LUFTDYKTIGHETSPÅBUD (LDP)

Tilbehør
Pacific
Scientific-1

15/80 KONTROLL OG UTSKIFTING AV SETEBELTELÅSER

PACIFIC
SCIENTIFIC - 2

Ny type Body Plate med
sort skive

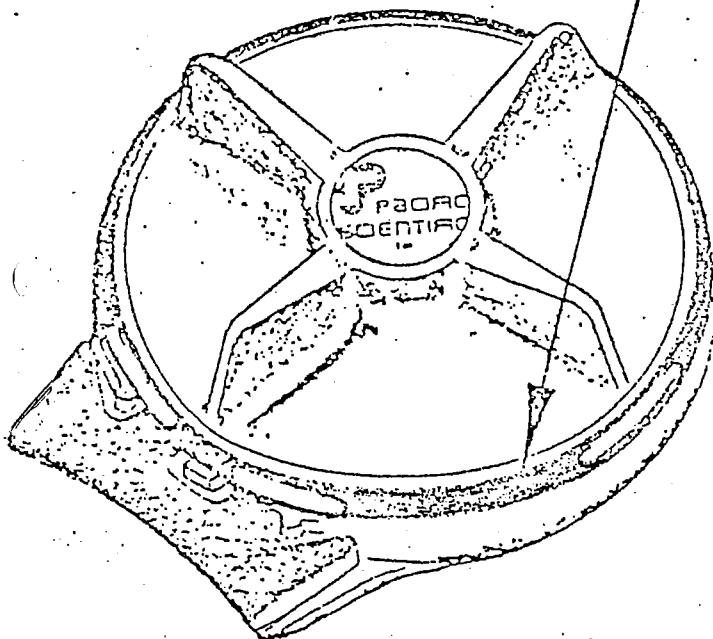
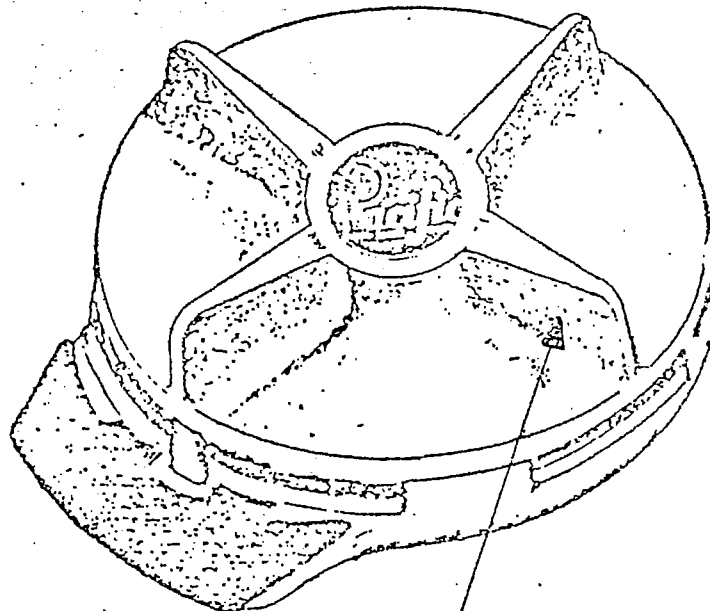
Kontroller om låsen har en sort plate under utløserplaten som vist på på skissen. Derom ingen sort plate finnes, skal beltelåsen skiftes ut med ny påmontert sort plate eller så skal hele beltet skiftes ut.
